# **FSC Report**

# ABP 307237-20

Proposed construction of a

FSC/19/4076

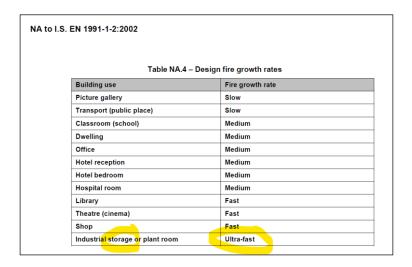
I do not concur with the Applicant that a Steady State 20.5MW Design Fire is appropriate in designing smoke and heat venting intended for the assistance of the fire service in an unsprinklered warehouse as is proposed in this instance and in particular a high bay warehouse where the flue effect between adjacent bays can result in rapid vertical and horizontal fire spread.

In this regard it is noted that PD 7974-1: 2019 suggests an Ultra-Fast fire growth rate for Cardboard and Plastic boxes in a vertical configuration as might be found in a high bay warehouse – see extract below.
